Jubilee Mutual Water Company/Gordon Acres Consolidation Project- Addendum

August 2023

CEQA Modification

This Addendum addresses the modified location of the proposed replacement well and adds detail to the proposed construction of the replacement well. According to California Code of Regulations, title 14, section 15164, "An addendum to an adopted negative declaration may be prepared if only minor technical changes or additions are necessary or none of the conditions described in Section 15162 calling for the preparation of a subsequent EIR or negative declaration have occurred." The Lead Agency has determined an addendum as the appropriate course of action as none of the conditions listed in section 15162 exist. The Project will not have one or more significant effects not discussed in the previous negative declaration, substantial changes, new information of substantial importance or any new mitigation measures that require the preparation of a subsequent negative declaration.

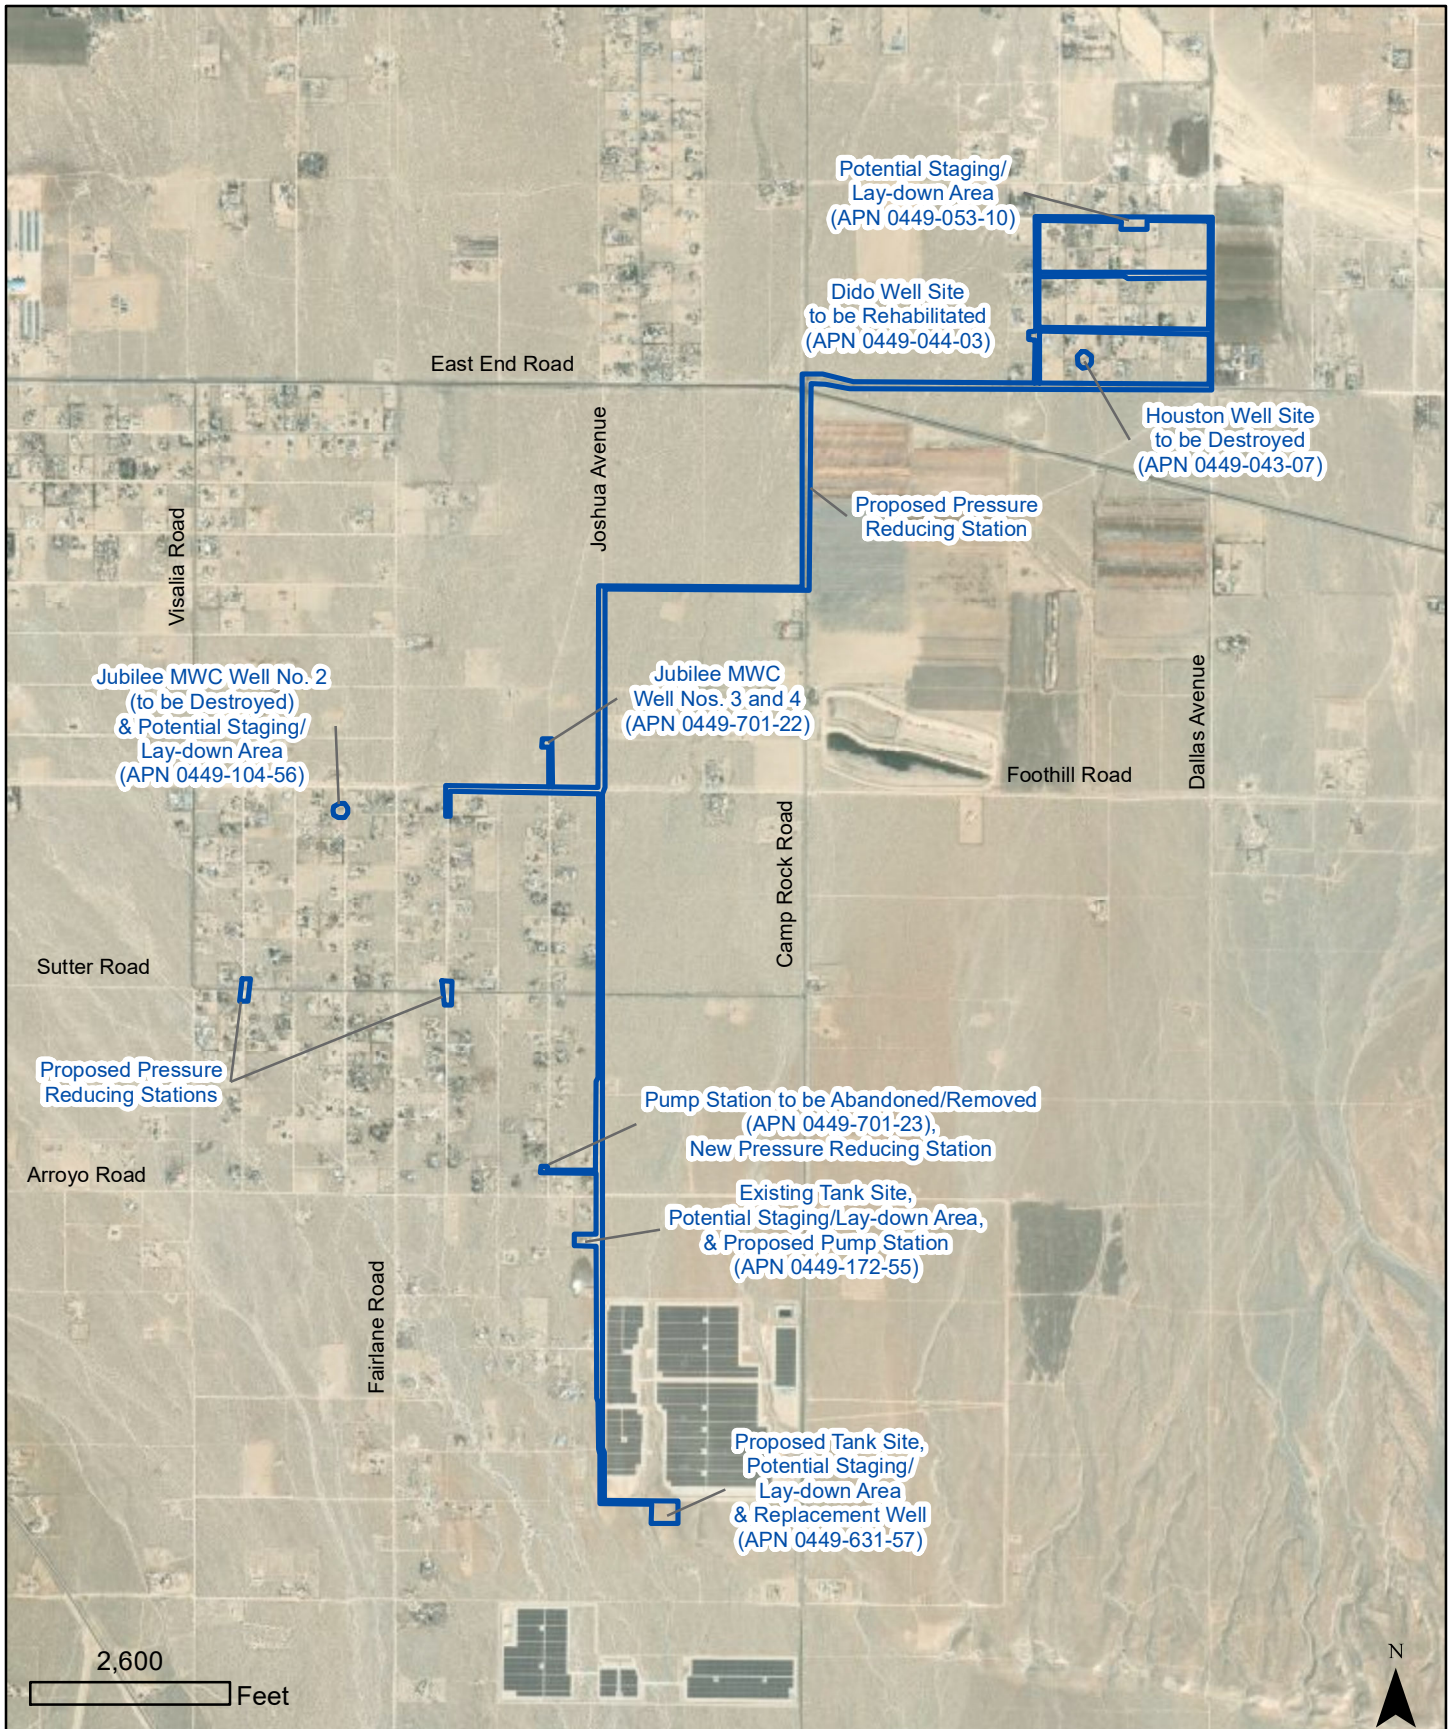
The proposed replacement well will be drilled on a JMWC-owned parcel (APN 0449-631-57), and not within the parcel containing the existing Well No. 4 (APN 0449-701-22). Electrical service to the well site will be provided by Southern California Edison. A temporary/portable electrical generator will be brought to the site for periodic system testing and during extended grid outages. The proposed well will have a final depth of approximately 600 feet, with a casing diameter of 10 inches. During drilling, a 6-inch pilot hole will be drilled to approximately 810 feet. The additional depth is proposed to investigate geologic conditions, including water production capacities and water quality at various depths.

The proposed well will connect to the proposed adjacent storage tanks via above and below grade piping and conduits, located in various locations on the northern end of APN 0449-631-57. The well, storage tanks, and generator will be surrounded by a new fence with gates. The site will be visited by JMWC personnel approximately daily. Contractors for well, generator, and storage tank maintenance, inspection, and equipment replacement will be present at the site approximately annually.

FIGURE 2

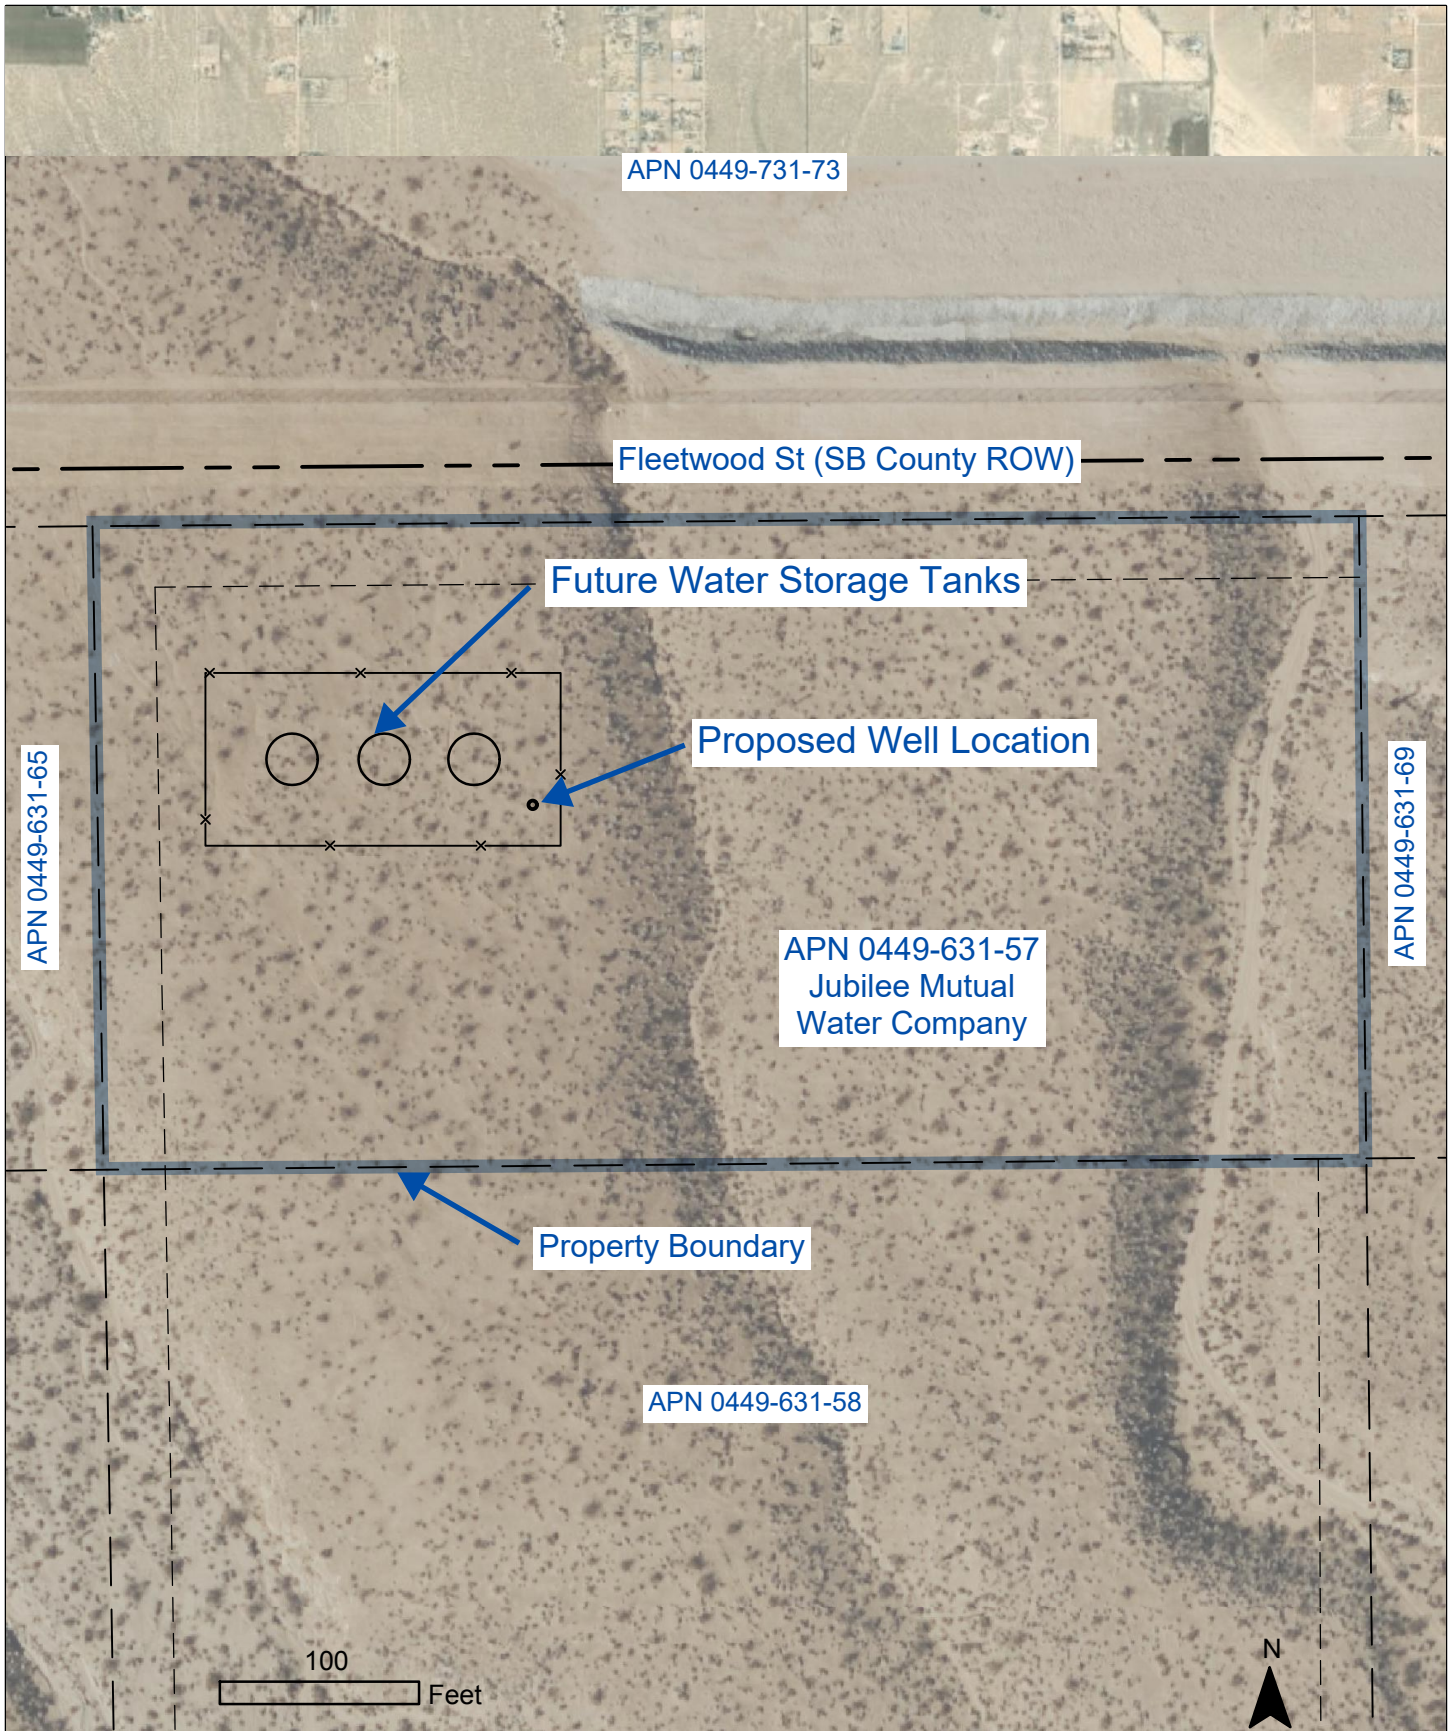
The Project's Initial Study and Mitigated Negative Declaration (IS/MND) notes a portion of the proposed Project will include "Replacement of (Jubilee Mutual Water Company's) existing Well No. 4 with a new well at the same site with depth and production approximating Well No. 4". In advance of construction, the project proponent, Jubilee Mutual Water Company (JMWC), purchased two adjacent parcels (APNs 0449-631-57 and 0449-631-69) in anticipation of developing storage tanks and a production well. The original IS/MND notes the replacement well will be located adjacent to Well No. 4 (APN 0449-701-22). JMWC desires to construct the replacement well on APN 0449-631-57, adjacent to the proposed storage tanks. The proposed location of the storage tanks is unchanged from the original IS/MND (APN 0449-631-57). Figure 1 shows the location of existing Well No. 4 and the revised location of the proposed replacement well. Figure 2 shows the location of the proposed well in relation to the proposed storage tanks and the property lines of APN 0449-631-57.
